Informal document GRPE-85-04-Rev.1 to amend
ECE/TRANS/WP.29/GRPE/2021/17
85th GRPE, 11-14 Jan-2021, Agenda item 4
This is a clean version including all proposed changes to
GRPE/2021/17.

Proposal for a new Consolidated Resolution concerning Exhaust Ultra-Fine Particle Number Measurement For Heavy Duty Engines

Proposal for a Consolidated Resolution on the exhaust ultra-fine particle number measurement for heavy duty engines

Examples of different SPN sampling configurations:

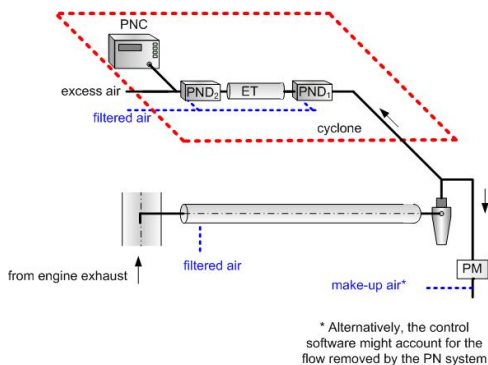
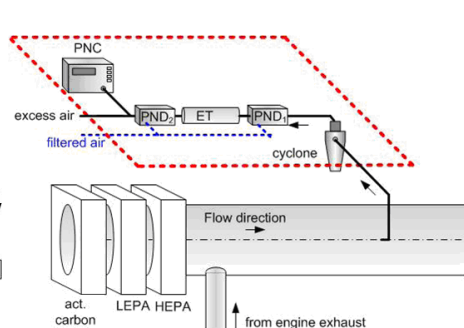
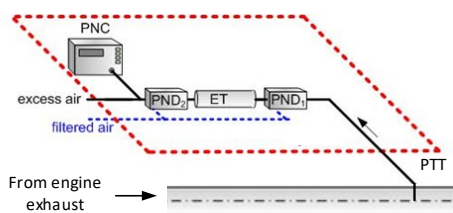
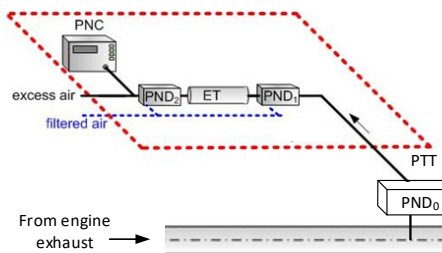
19. The modifications introduced to UN Regulation No. 49 aims mainly at introducing as an alternative option the possibility to measure solid particle number (SPN) directly from the tailpipe with fixed dilution, in addition to the currently allowed options of measuring from a proportional partial flow system or the full dilution tunnel.

Sampling line	When sampling directly from the tailpipe the residence time until the pre-diluter or the VPR shall be ≤ 1 seconds. The tubing shall be heated at $\geq 150^{\circ}\text{C}$ if ≥ 10 cm Good engineering judgment should be applied to minimise particle losses and insulate unheated parts.	Reduced residence time, hot sampling line to avoid condensation and minimise particle losses

Figure 21
Schematic of recommended particle sampling system – Tailpipe sampling (i) without pre-diluter; (ii) with pre-diluter.

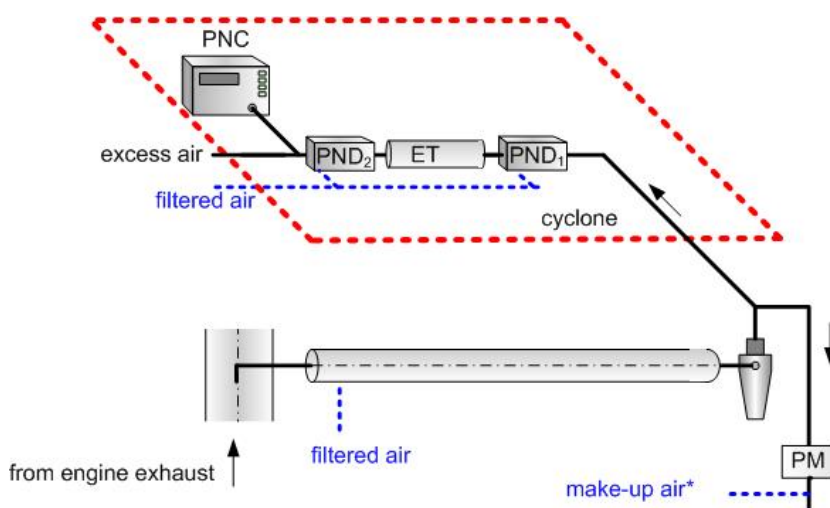
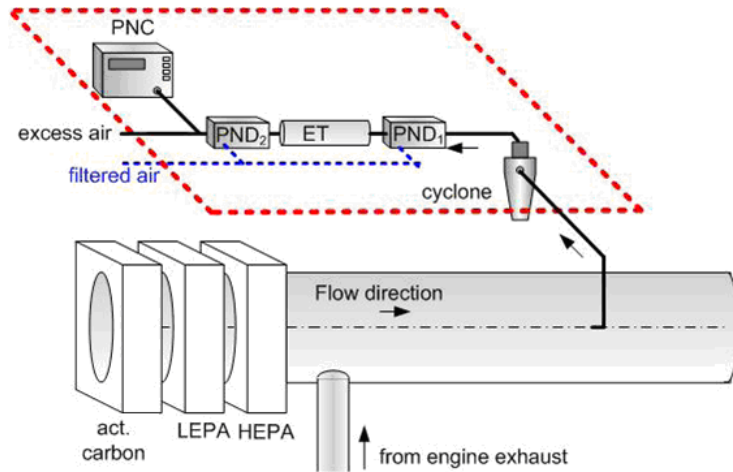
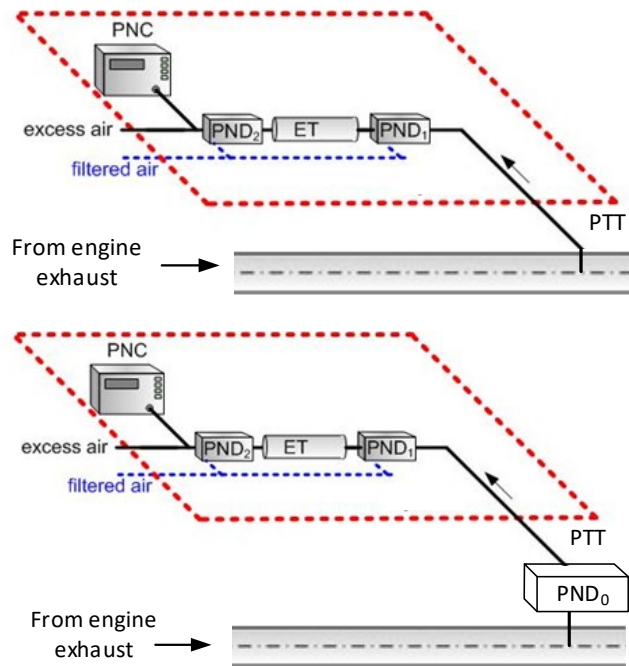
A cold or hot pre-diluter may be located at the end of the particle sampling probe and in front of the PTT. A fixed dilution ratio >5:1 shall be applied to the cold or hot dilution stage. Cold dilution is defined as a dilution with (unheated) dilution air and/or diluter temperature $\geq 20^{\circ}\text{C}$. Indicators of whether temperatures (if applicable) and dilutions are at their correct operating ranges shall be provided.
